STATE OF CALIFORNIA CALIFORNIA NATURAL RESOURCES AGENCY DEPARTMENT OF WATER RESOURCES DIVISION OF SAFETY OF DAMS

INSPECTION OF DAM AND RESERVOIR IN CERTIFIED STATUS

Name of Dam _	Seeger (Nicasio)	Dam No	33-8	
		Data di la sancia	5 April 2016	
		Date of Inspection	5 April 2016

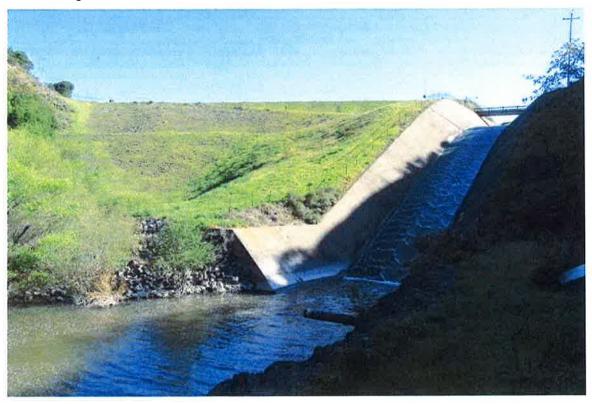
The upstream face as viewed from the upstream end of the spillway channel. The large boulder riprap face protection remains in good condition.
